PLANNING AND ZONING COMMISSION
Wednesday, February 18, 2026, 4:30 PM
191 5th Street West, Ketchum, Idaho 83340

STAFF REPORT KETCHUM PLANNING AND ZONING COMMISSION REGULAR MEETING OF FEBRUARY 18, 2026

STAFF REPORT
KETCHUM PLANNING AND ZONING COMMISSION
REGULAR MEETING OF FEBRUARY 18, 2026

LIFT VIEW TOWNHOMES
310 GEORGIA RD
RENDERINGS

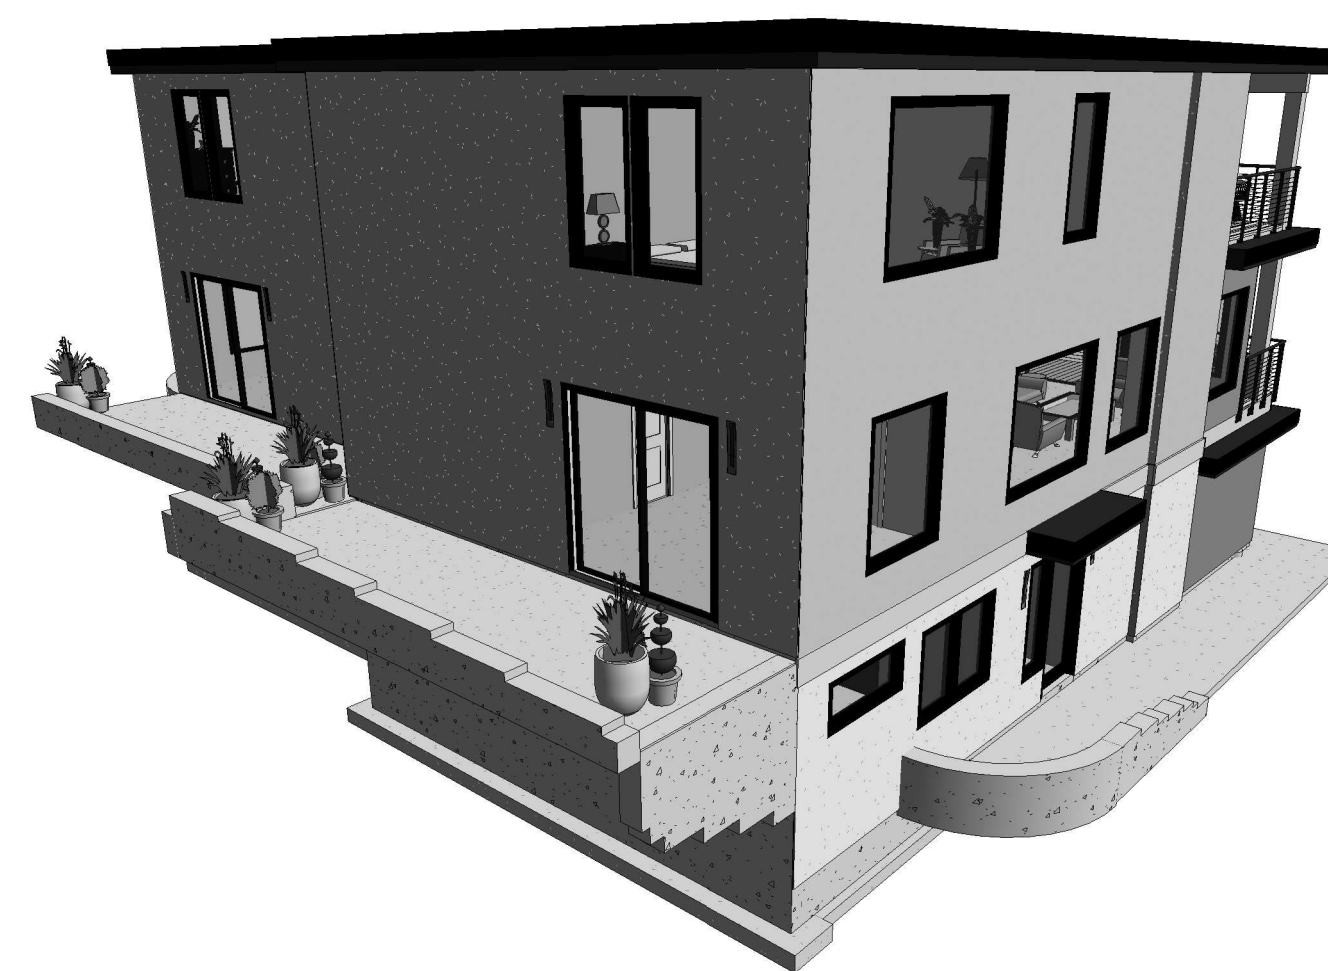
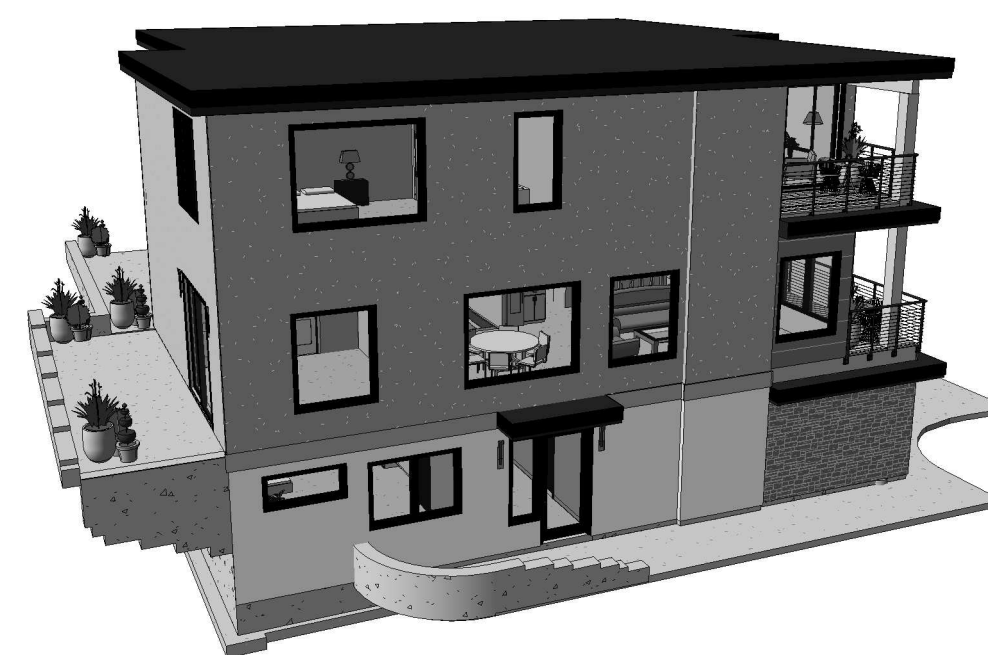
The proposed development includes two attached townhomes which are identical and utilize mountain modern design (see figure 2 below for a rendering of the project). The applicant made the following design changes to provide more undulation and relief to the front façade:

- Added horizontal bands that overhang the second and third floors
- A recessed step added to the roof line fascia
- Stepped back third floor 2' from front façade
- Changed the color gradient of materials on the front façade from dark (Merrillstone Montana Mossy Stone) on the bottom to the beige stucco at the top to give the structure a more grounded appearance.

Staff believes these changes help add visual interest and reduce the bulk of the duplex at the front façade, however, staff still find that the overall structure presents a tall, minimally varied wall plane with little relief of the massing. While the second-floor steps back 7 feet from the ground floor, the effectiveness of the 7-foot step back at the second floor is diminished as the third floor projection above completely covers the recession created by the second-floor patio. Staff does acknowledge that the units are offset from each other by 5 feet at all three floor levels which helps break up the horizontal wall plane of the duplex's front façade. However, staff find that the proposed flat roof further accentuates the overall massing and horizontal emphasis of the structure, contributing to the boxy appearance. In addition to the flat roof form, the pronounced metal fascia in contrast to the beige stucco appears top-heavy and exacerbates the duplex's boxy appearance. Without variation in roof form or increased wall undulation on the third story, the design lacks articulation that could otherwise help break down the building's scale and reduce its perceived bulk. Staff requests the Commission to review the proposal and provide feedback on whether the project sufficiently incorporates architectural features and if it adequately reduces the appearance of bulk and flatness.

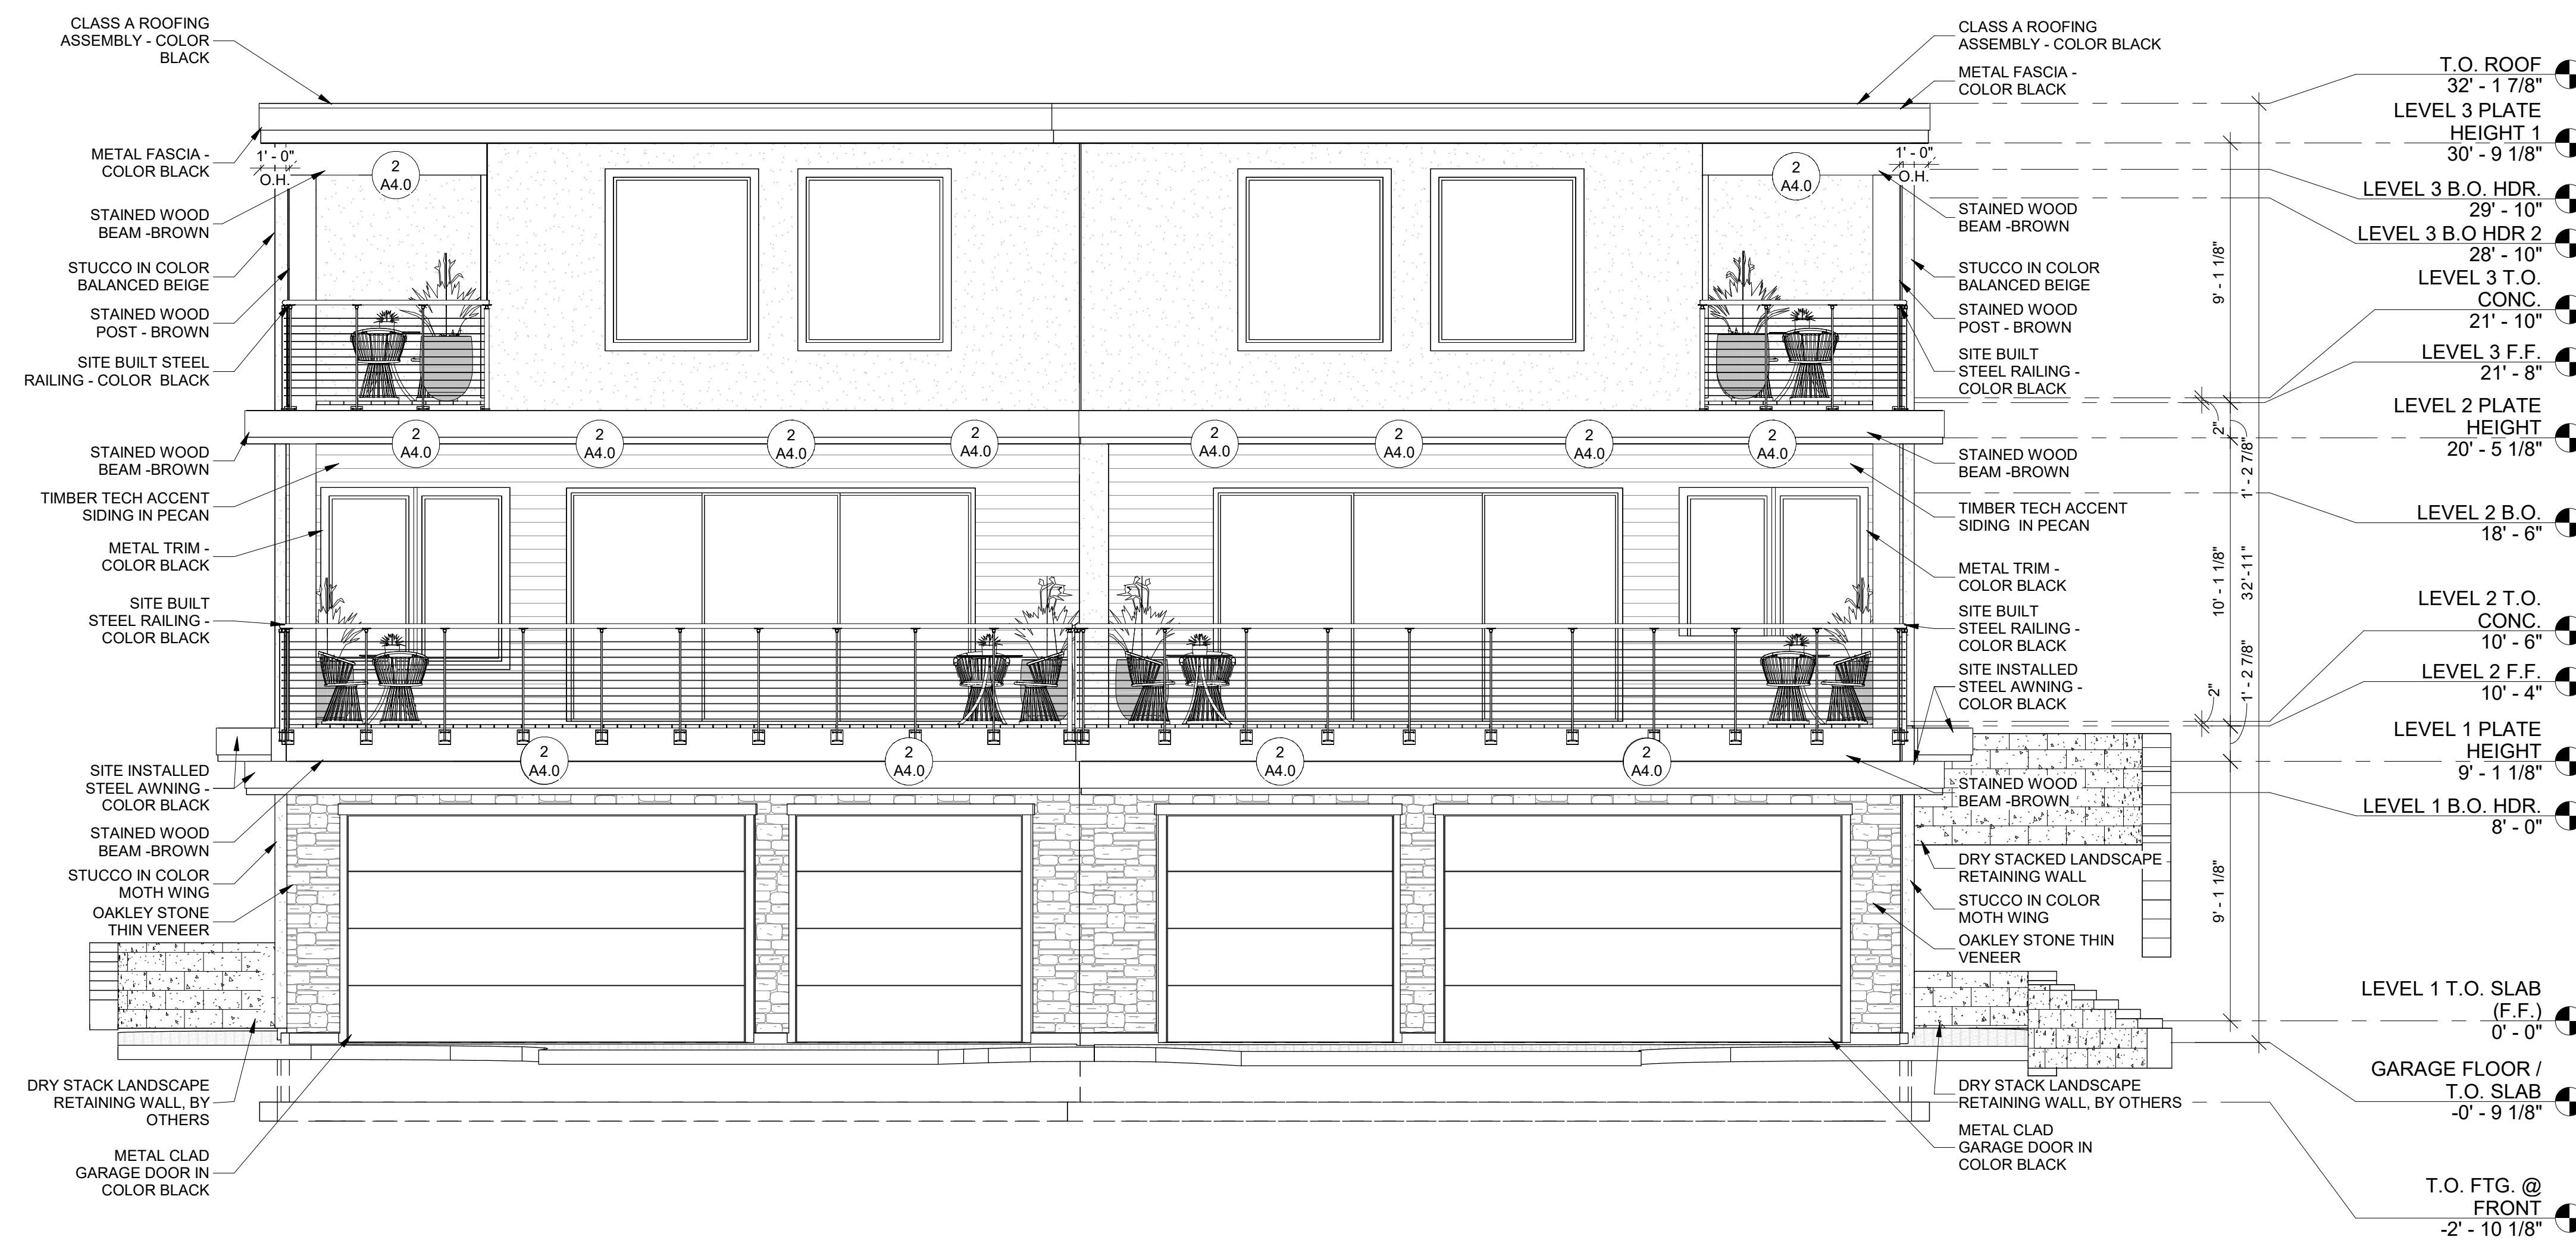
Pursuant to KMC §17.96.060.F6, buildings shall be oriented toward their primary street frontage. Staff does not believe the proposed design meets this standard because the street facing ground level elevation is dominated by garages doors while the primary entrances to both units are located on the sides of the structure and set far back on the side walls and are barely visible from the street. The applicant team revised the initial design to include steel awnings over the front entrances to better identify the entryways, however, the entrances remain oriented to the sides of the property and not the street frontage. By distinguishing the front-door entrances compared to the garage entrance creates a more active frontage that is more compatible with the orientation of homes in the surrounding neighborhood. Staff believes that by modifying the ground-floor design to reduce the

dominance of garage door openings and distinguishing the front-door entrances would help add visual interest and relief to the front façade at the ground floor. Staff requests the Commission to review the proposal and provide feedback on whether this standard is sufficiently met.

C1.10

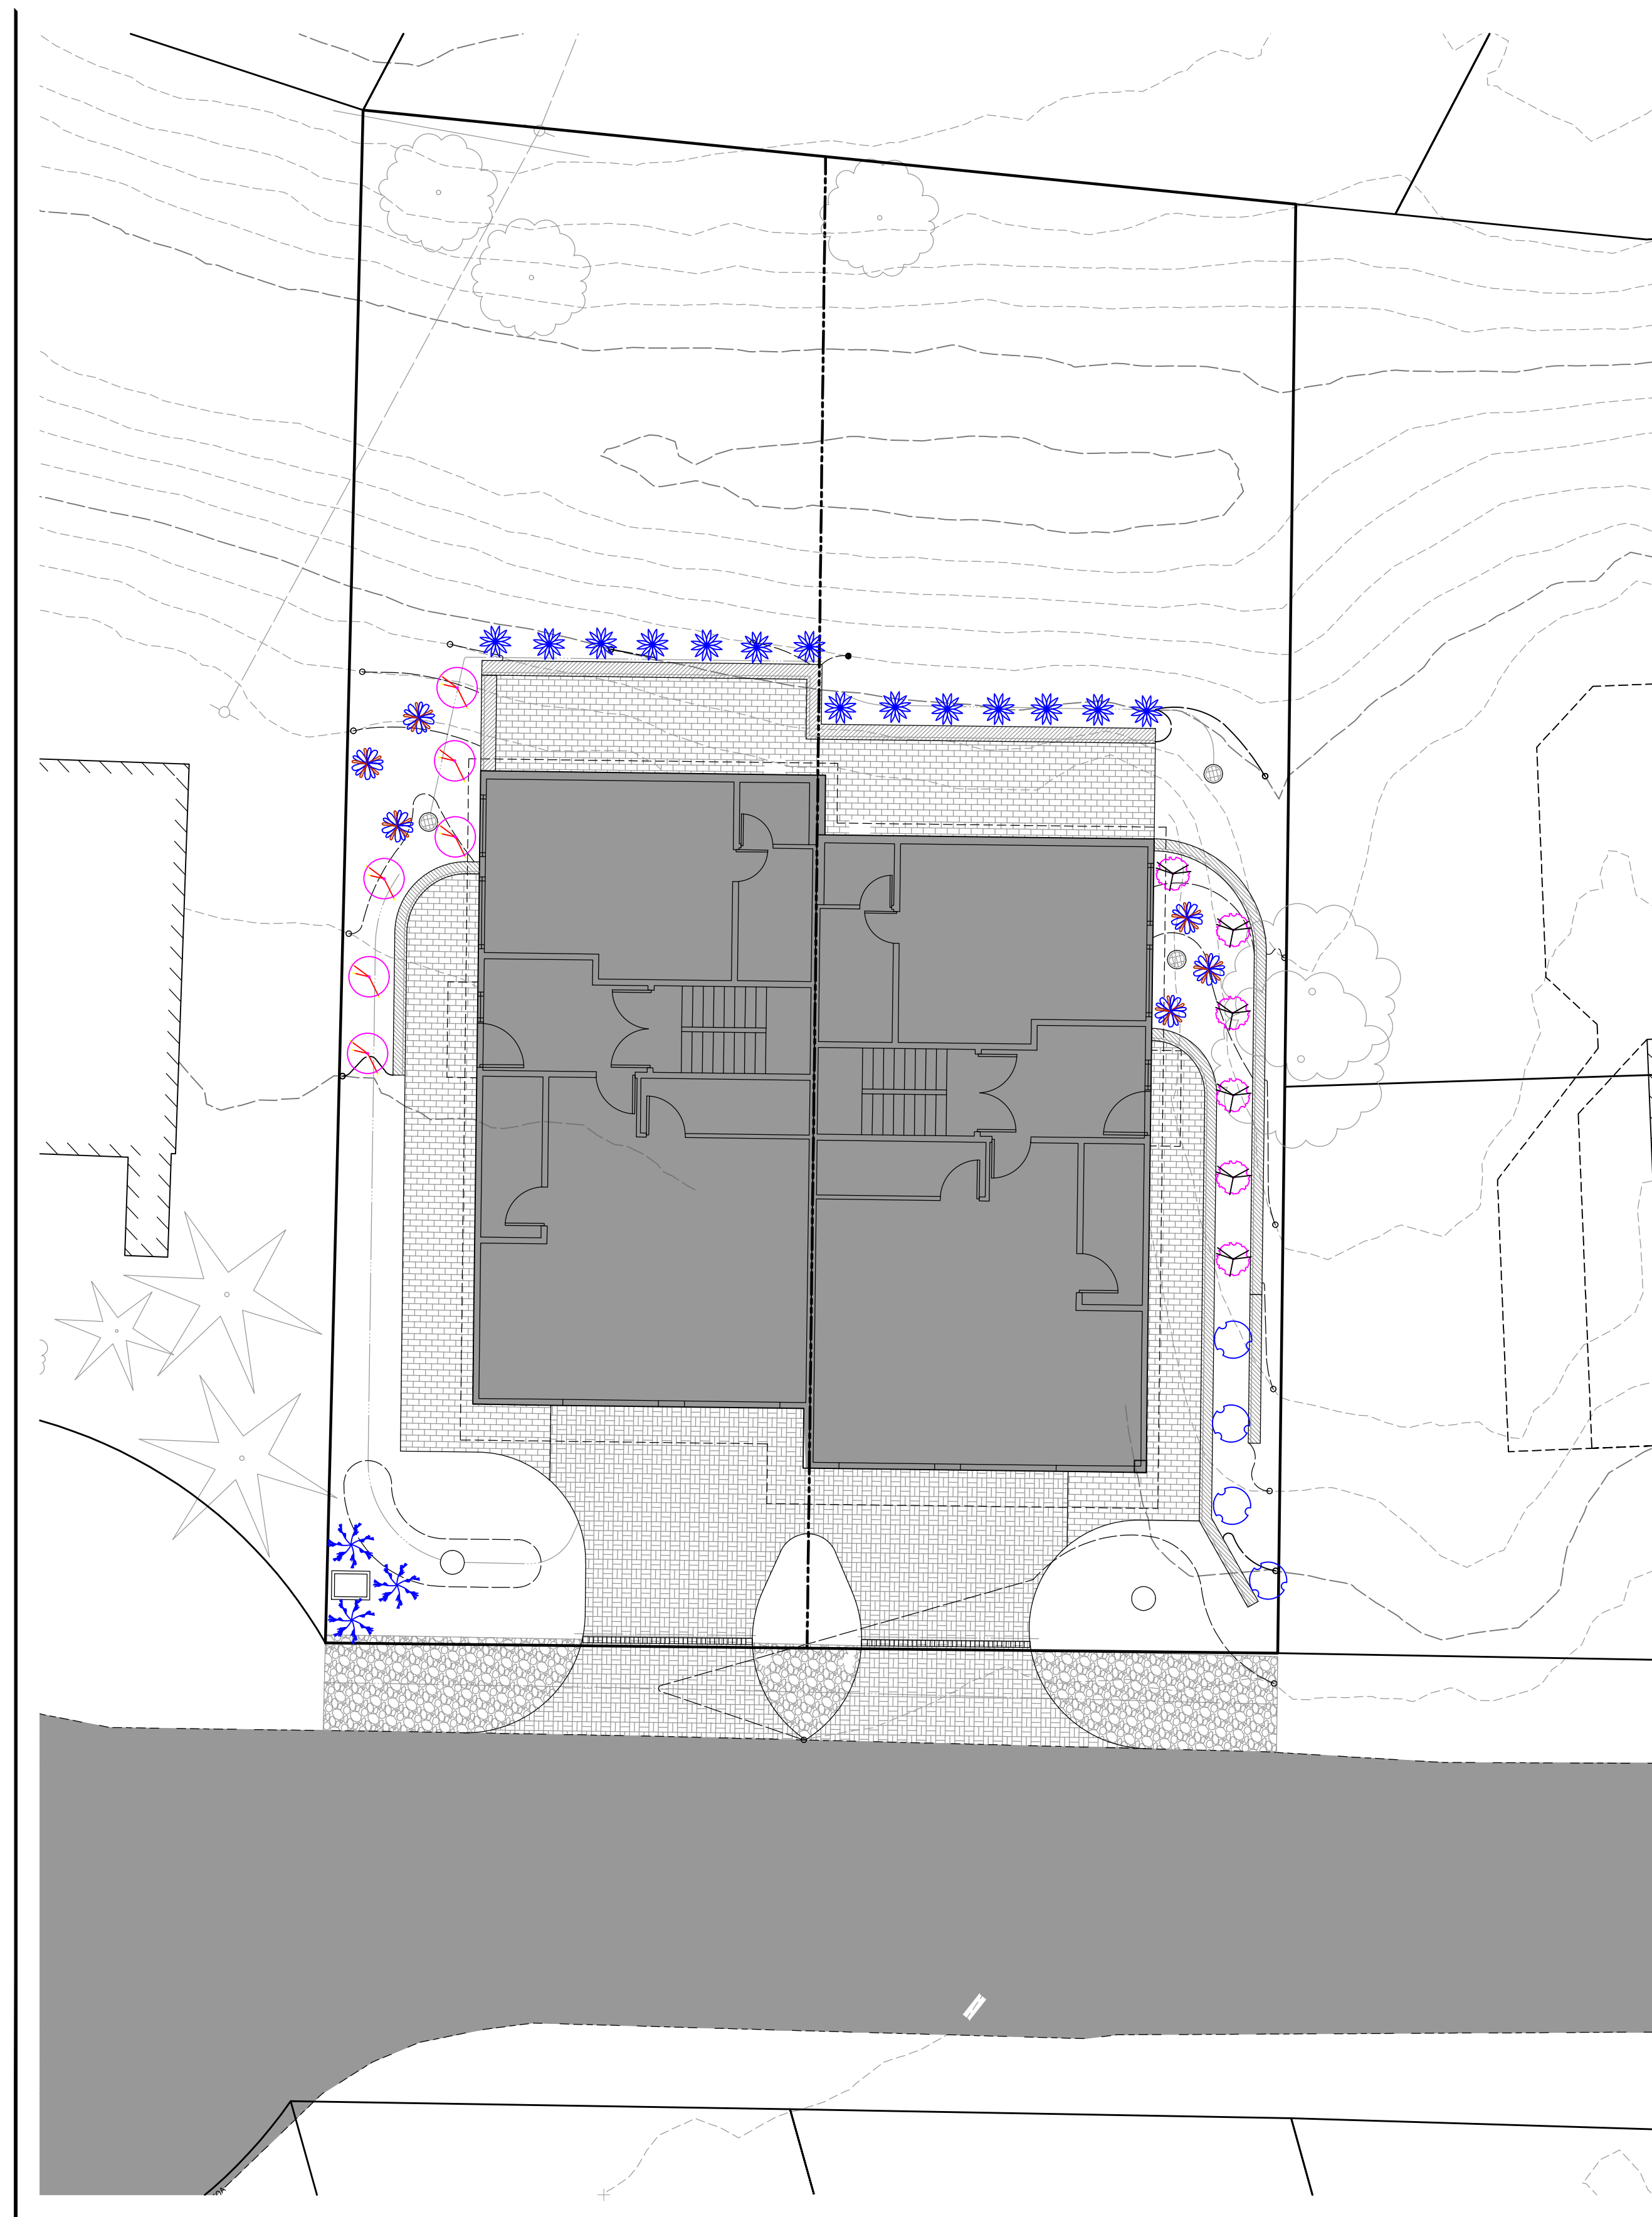
17.96.060.C.1 - Drainage	Conformance
<i>All stormwater shall be retained on site.</i>	YES
Finding: Pursuant to KMC §17.96.060.C.1, all storm water drainage shall be retained on site. Drainage improvements are specified on Sheet C1.00 of the project plans. The drainage improvements include the installation of a trench drain bordering the width of both driveways at the property line. A combination of drywells and catch basins will be installed to collect

17.96.060.H.1 – Snow Storage	Conformance
<i>Snow storage areas shall not be less than 30 percent of the improved parking and pedestrian circulation areas.</i>	YES
Finding: Sheet C1.00 of the project plans indicates that the proposed driveways will be snowmelted, which is permitted in lieu of providing snow storage areas onsite.
